5 July 2018
Ref: J2266L_3.docx

**PROPOSED RESIDENTIAL CARE FACILITY (RCF) – OPAL AGED CARE
TOONGABBIE SPORTS AND RECREATION CLUB & ADJACENT LOTS
CITY OF PARRAMATTA COUNCIL DA/1281/2016
INDEPENDENT REVIEW OF FLOOD RISKS**

The purpose of this review is to respond to item 5 in the 'Scope of Work' section of the Brief. This requires the reviewer to report on "... *the impacts of flooding on the proposed development of a residential care facility at the site ...*" including responses to seven matters listed within item 5 of the Brief.

Figure 1: The Site superimposed on Council's Flood Map
(Source: Attachment A of Martens & Assoc letter dated 31 May 2018)

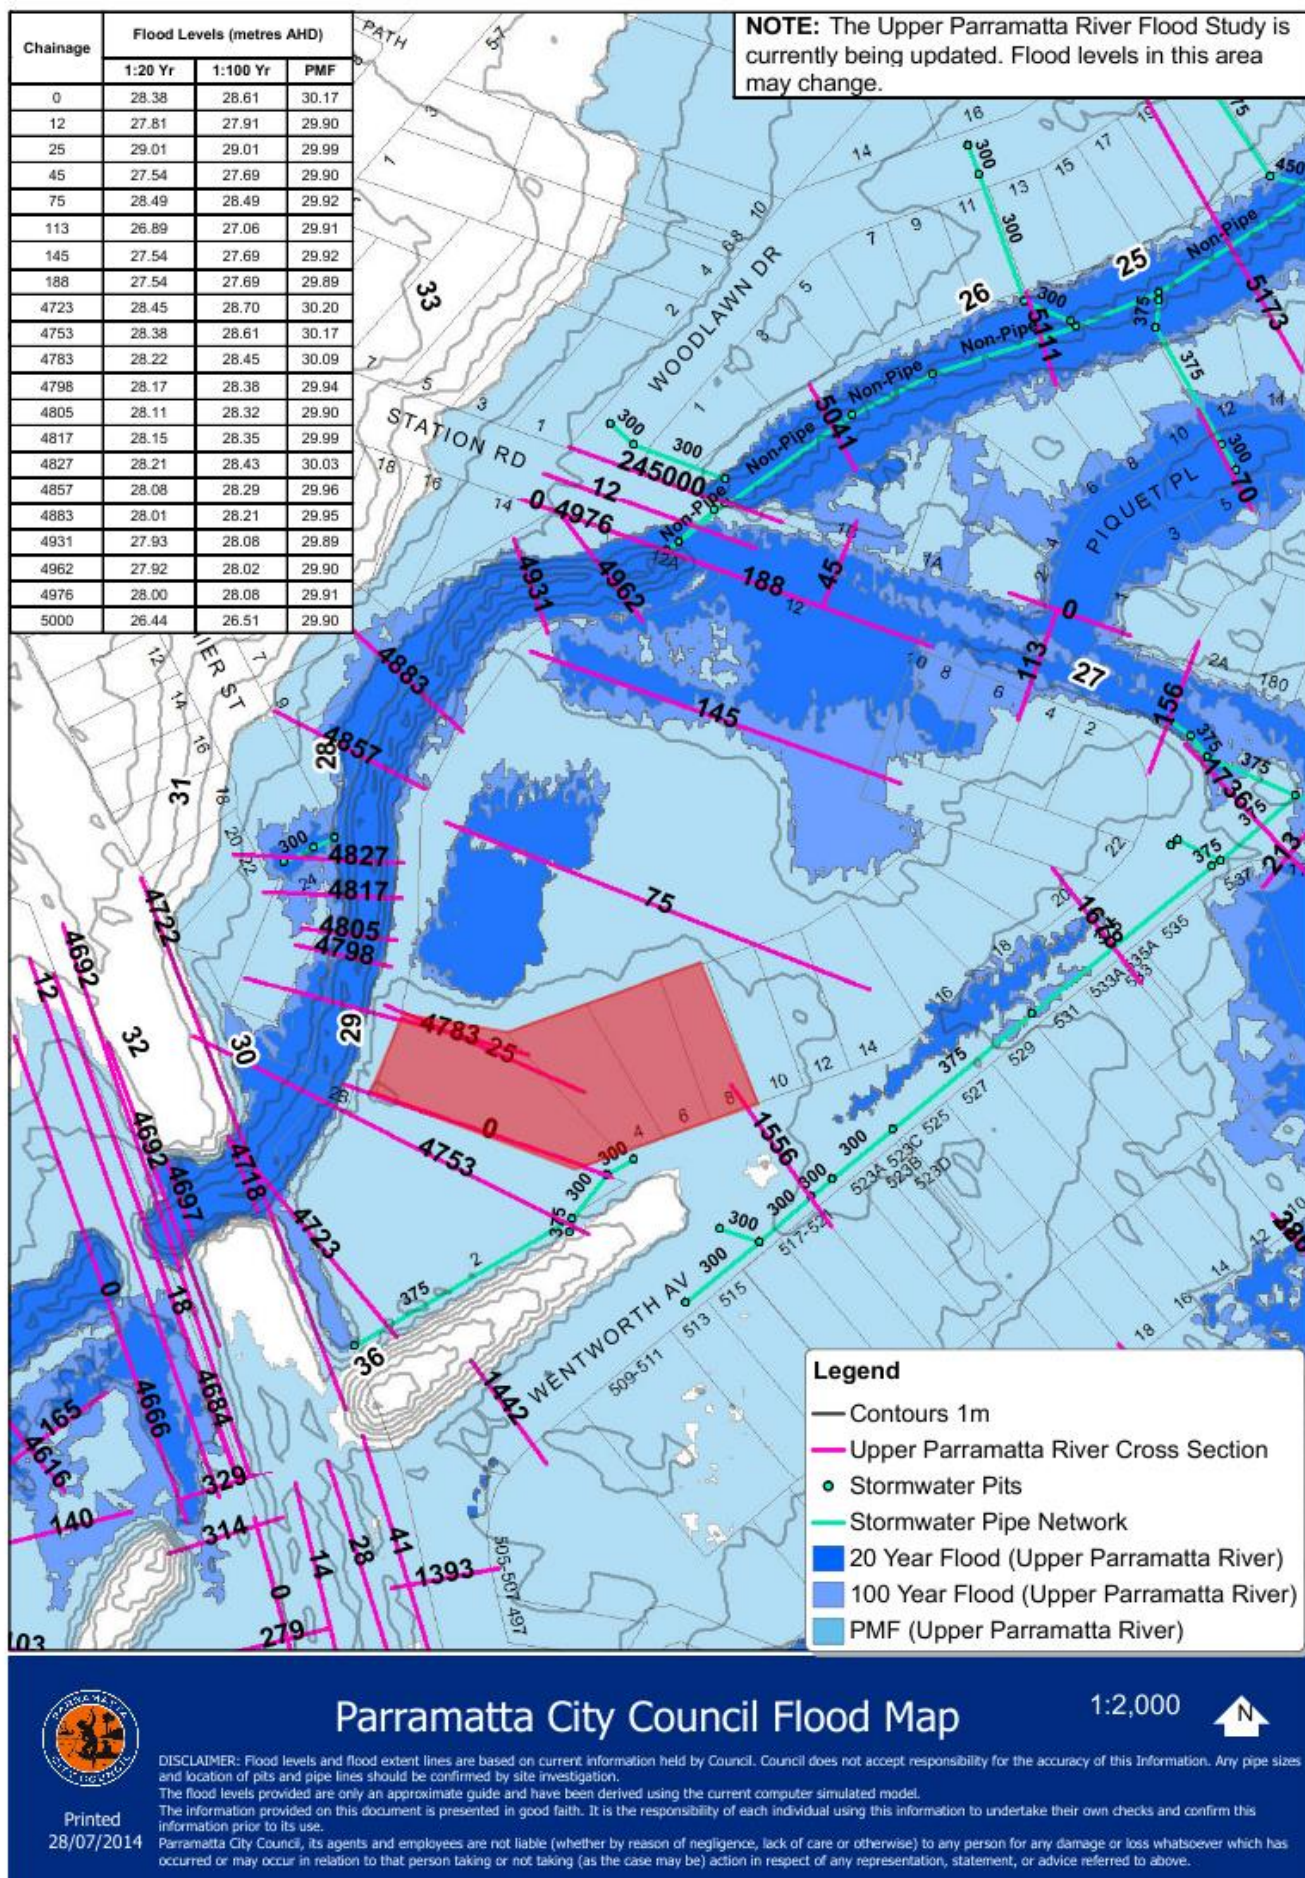
- (b) “... the proposed building siting in the floodway ...”.⁶ (The Site is not in a floodway);
 - (c) “Although the building footprint is technically above the 1% flood level, much of this site is below”.⁷ (None of the Site is below the 100 year flood level – refer **Figure 1**);

- (d) “... much of the site is flood affected during the 1% AEP event ...”.⁸ (None of the Site is inundated in a 1% AEP flood event – refer **Figure 1**).

Figure 2: The Site superimposed on Council's Flood Hazard Map

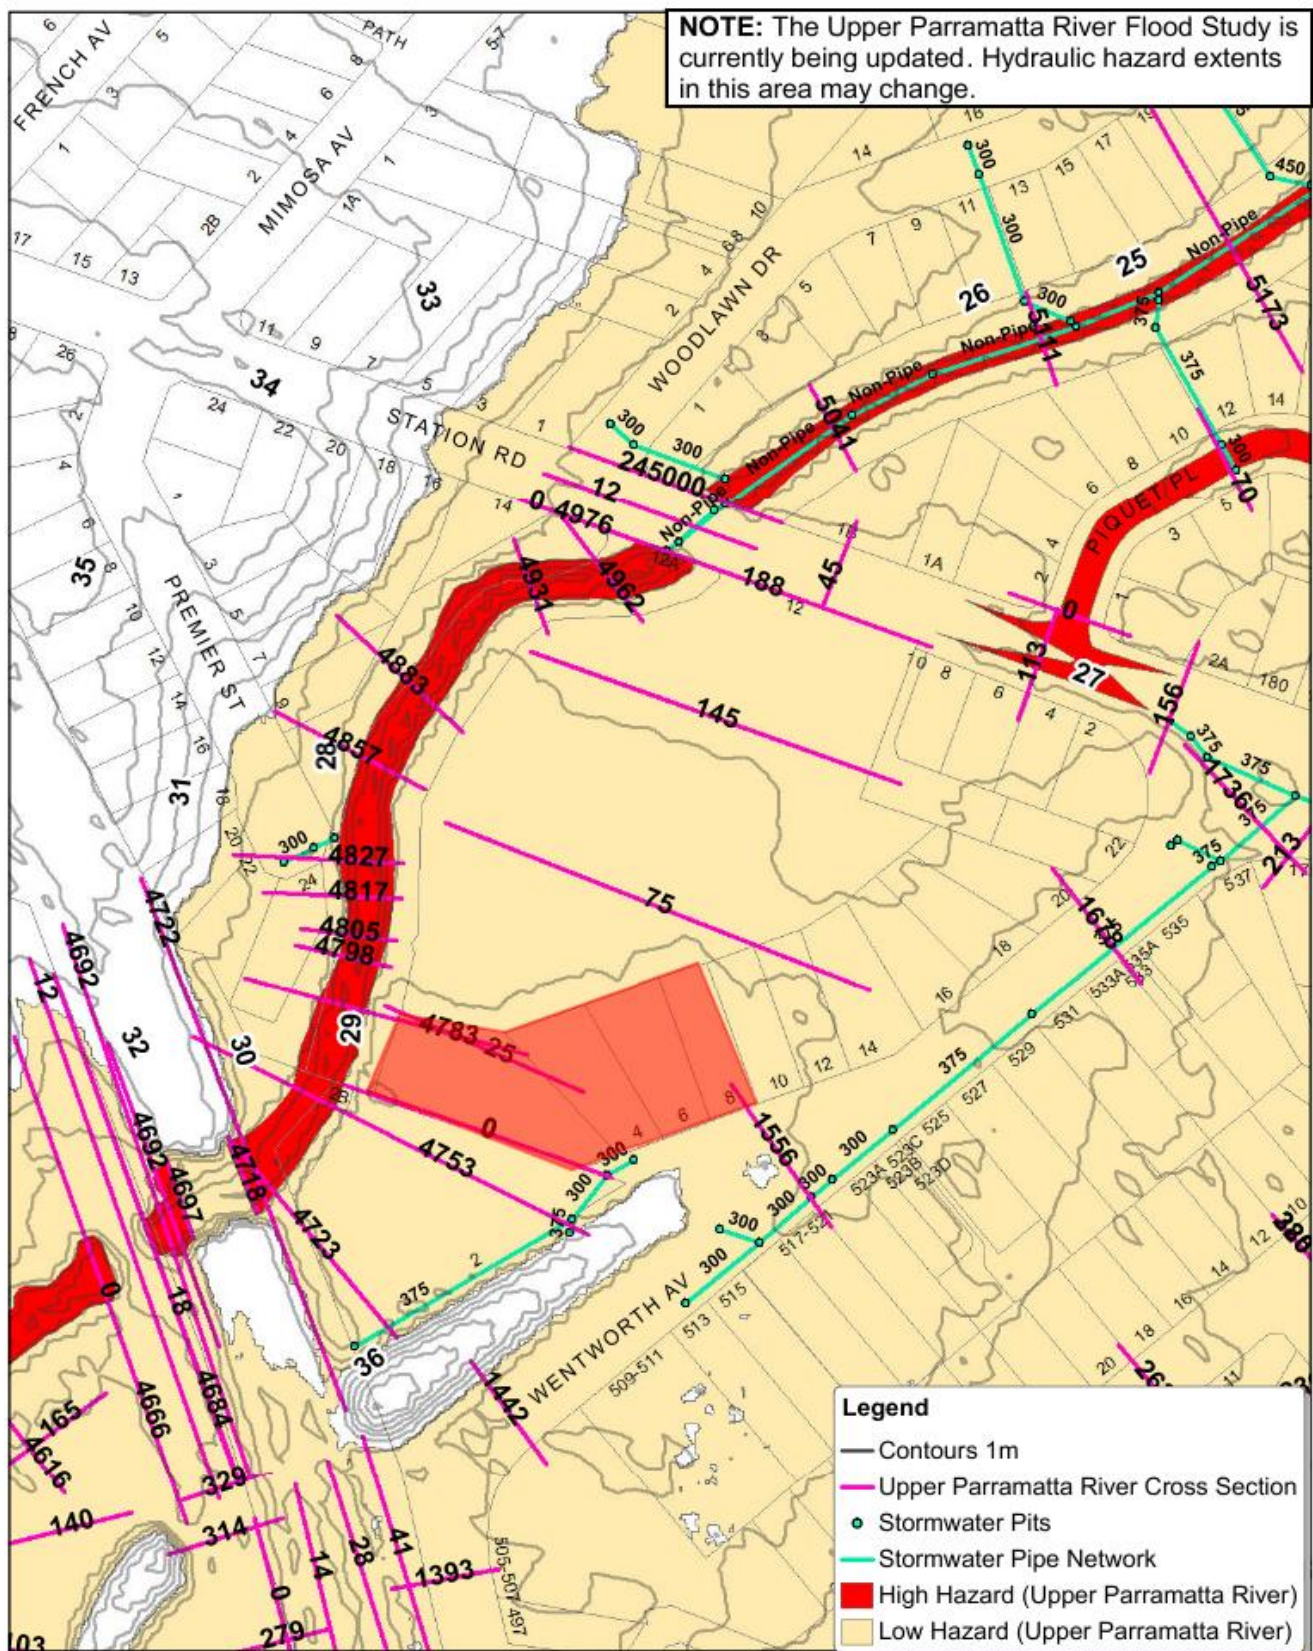
- (a) “The site and the surrounding area are subject to major low, medium and high hazard flooding”.⁵ (As can be seen from **Figure 2** the entirety of the Site is on low hazard land);
